Memo

To: Zoning Board Chairperson McGinley and Secretary Carpinelli
From: Plan Review Committee of the Verona Environmental Commission
c: Verona Environmental Commission Chair
Date: December 29, 2025
Re: **Case # 2026-03**
21-25 Grove Avenue [Block 1702, Lot 22]
Verona, New Jersey
Zone: C-2 (Professional Office and Business)

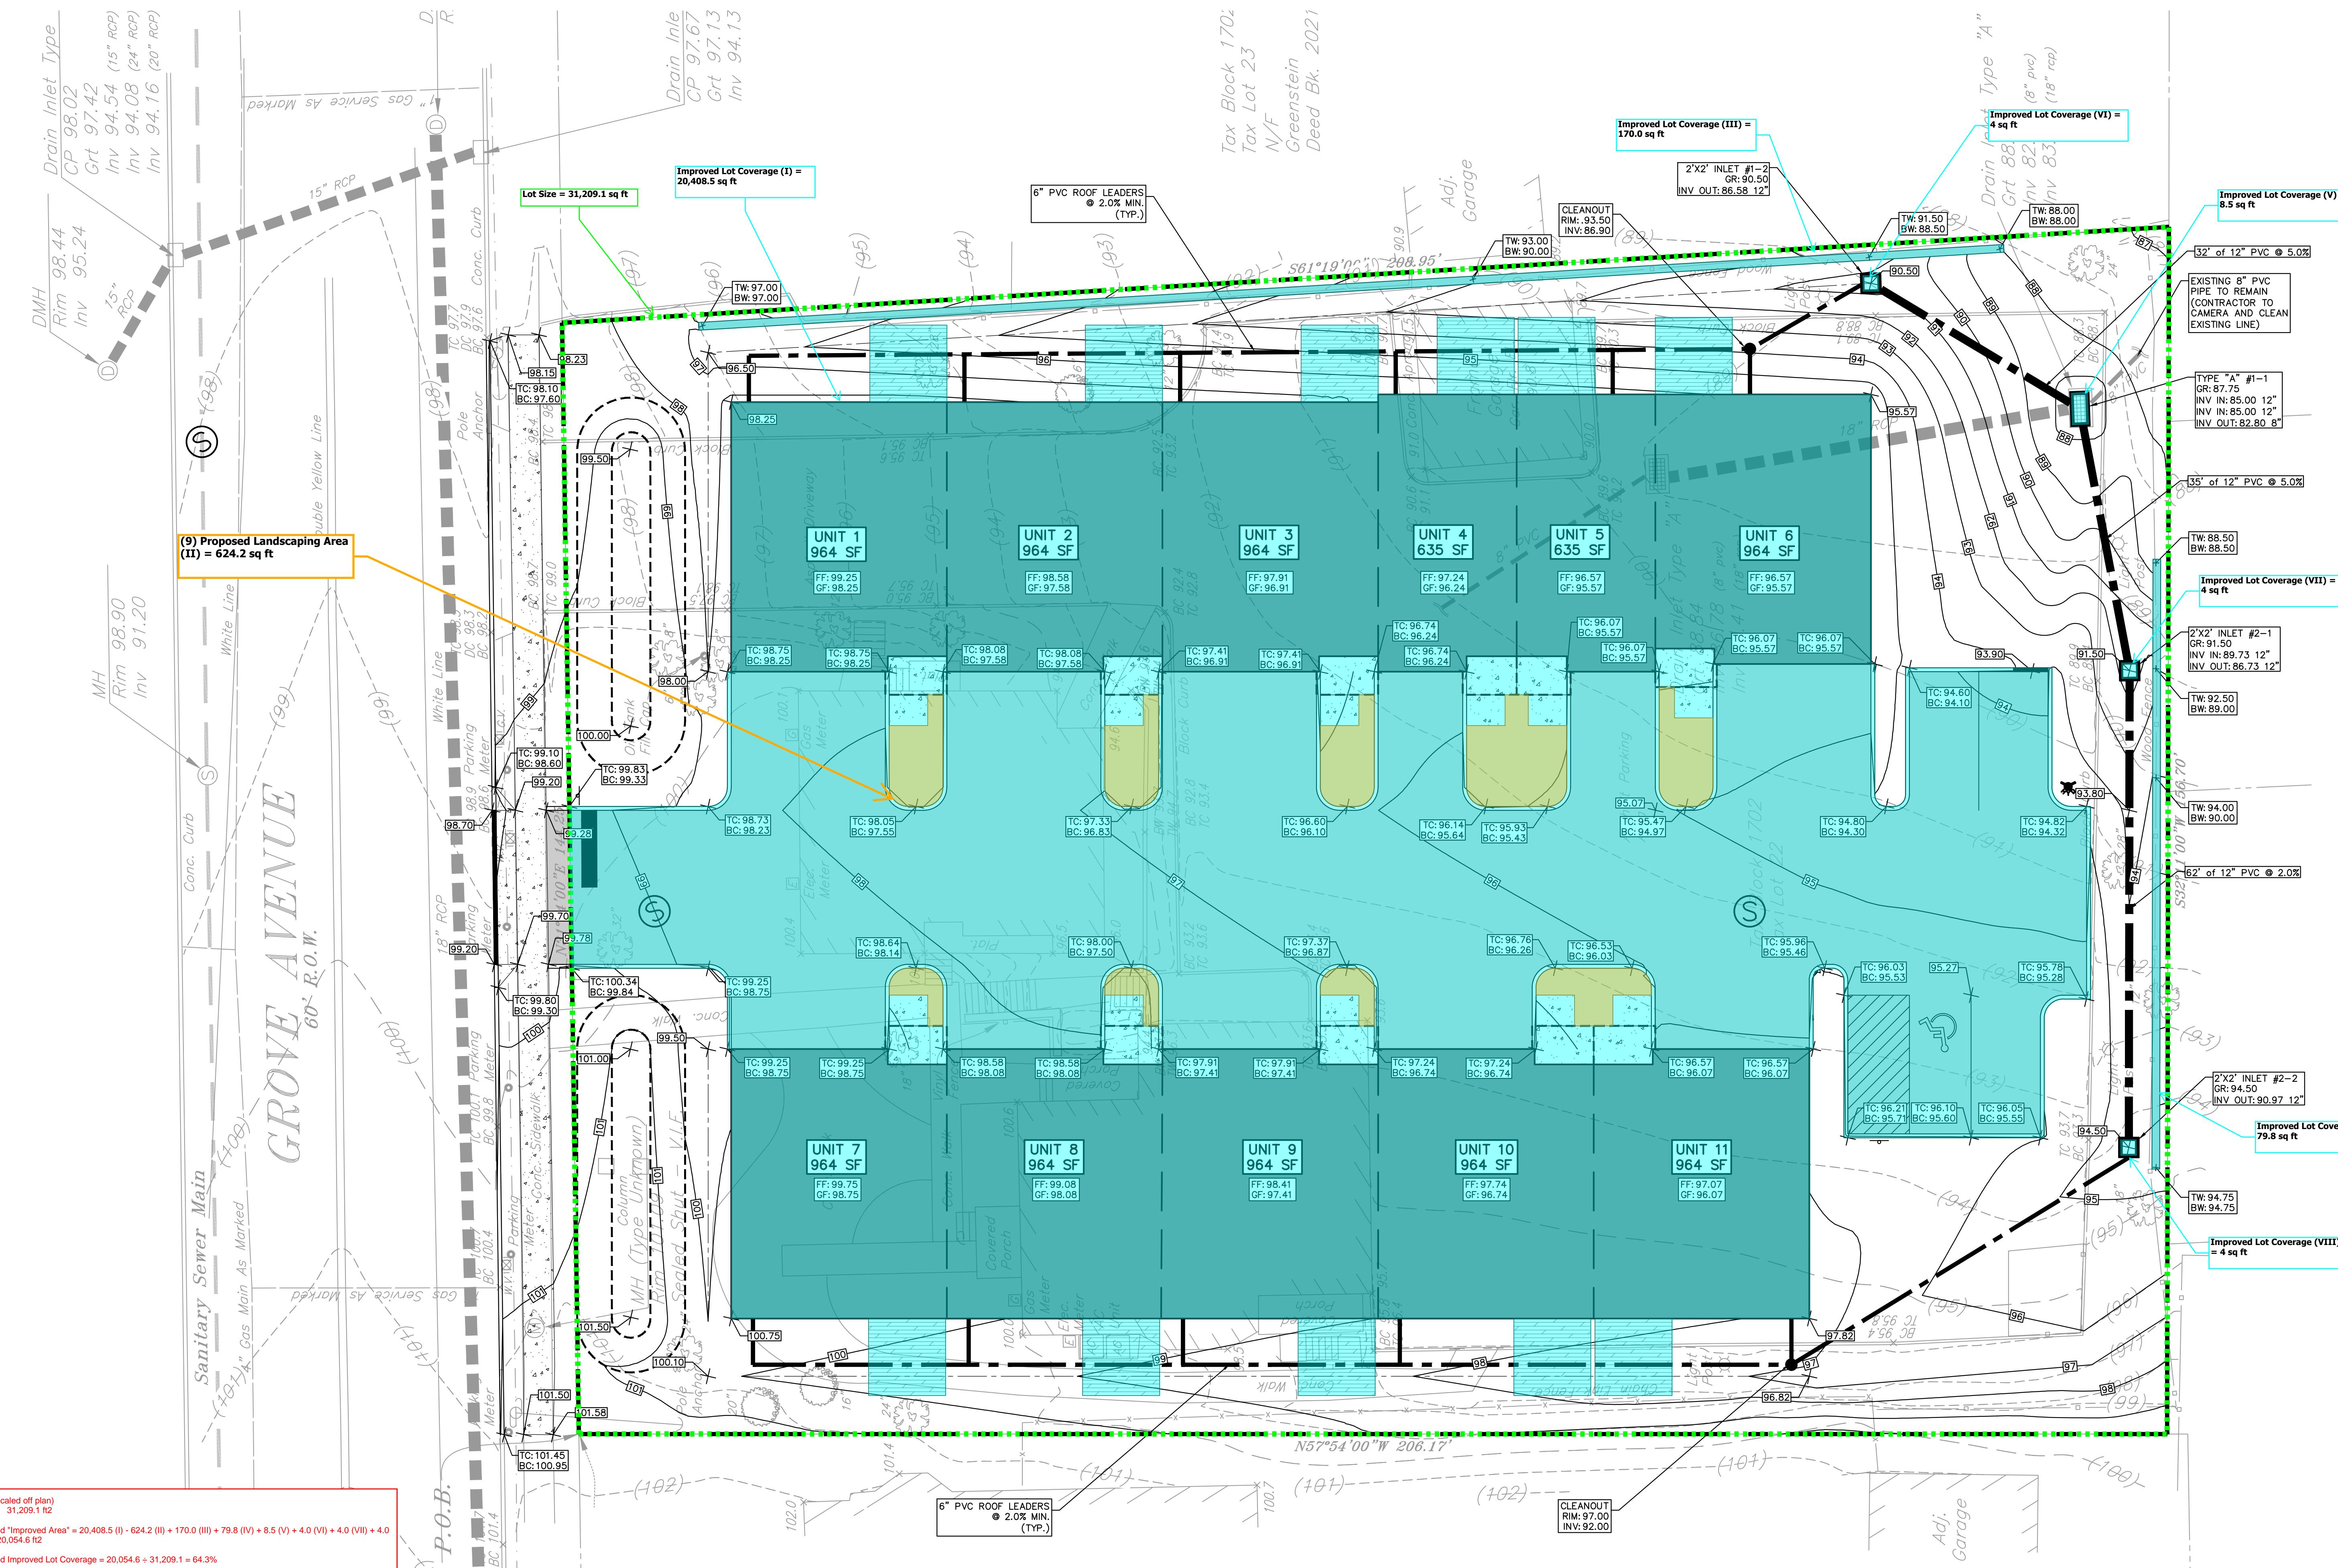
- 2) Existing and Proposed Total Improved Lot Coverage is listed as 69.4% (21,651 ft²) and 61.8% (19,293 ft²) on the Sheet SP-1, respectively. Scaling off the drawing, we calculated a Proposed Improved Lot Coverage of 64.3% based on a Proposed "Improved Area" of 20,055 ft² (please see attached annotated pdf). We understand that the maximum Improved Lot Coverage for the C-2 Zone is 65%.

Areas (scaled off plan)
Lot size 31,209.1 ft²

Proposed "Improved Area" = 20,408.5 (I) - 624.2 (II) + 170.0 (III) + 79.8 (IV) + 8.5 (V) + 4.0 (VI) + 4.0 (VII) + 4.0 (VIII) = 20,054.6 ft²

Proposed Improved Lot Coverage = $20,054.6 \div 31,209.1 = 64.3\%$
